Mississippi State University

Request for Proposals 18-51

High Performance Computing System

Questions and Answers

COMPUTER ROOM ENLARGED MECHANICAL PLAN

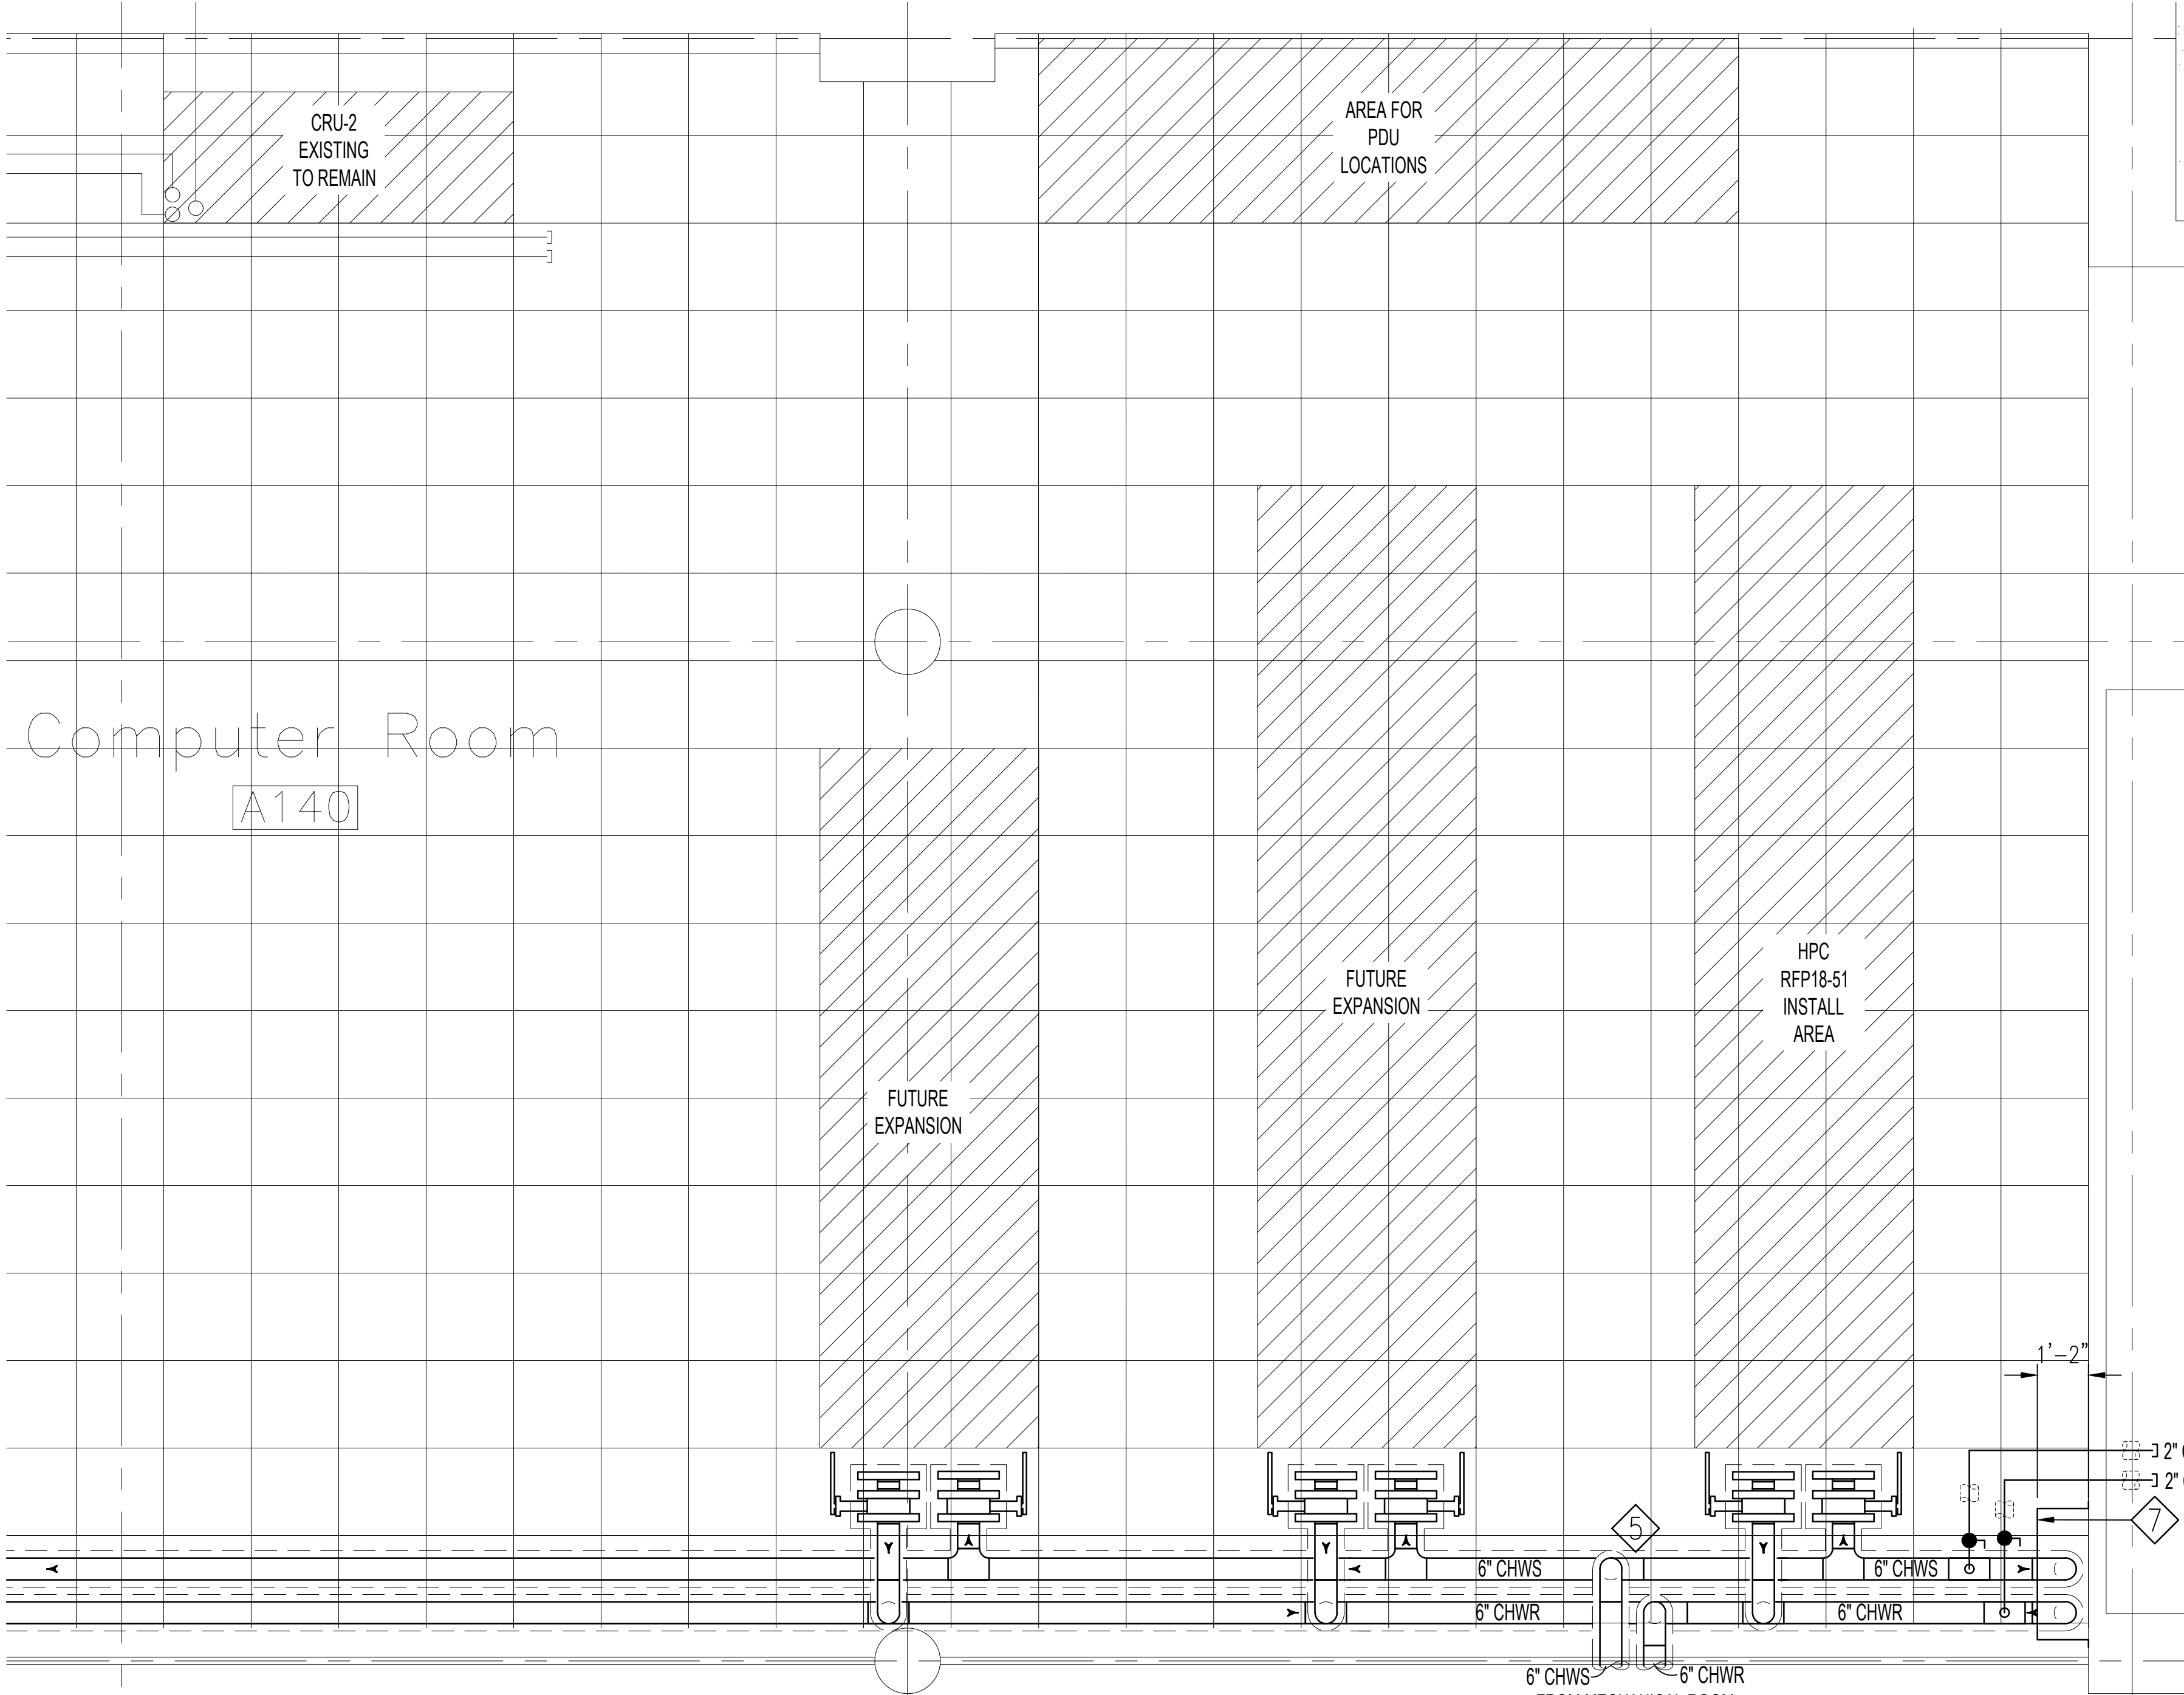
Q3. Are there any drawings of the room/facility where this equipment will go? If so, could you please provide them to us.

Q5. The RFP states that MSU will install the module power distribution unit. Will the MPDU be installed at same location as compute racks? Can MSU provide us a floor layout and status where the MPDU will be located so we can estimate the MPDU power pole to rack level PDU length? The Module Power Distribution Unit is about the size of a standard 19" rack.

A3. Yes (attached)

A5. The PDU/RPP will not be installed inline with the compute racks, but will be located in close proximity. See attached drawing.
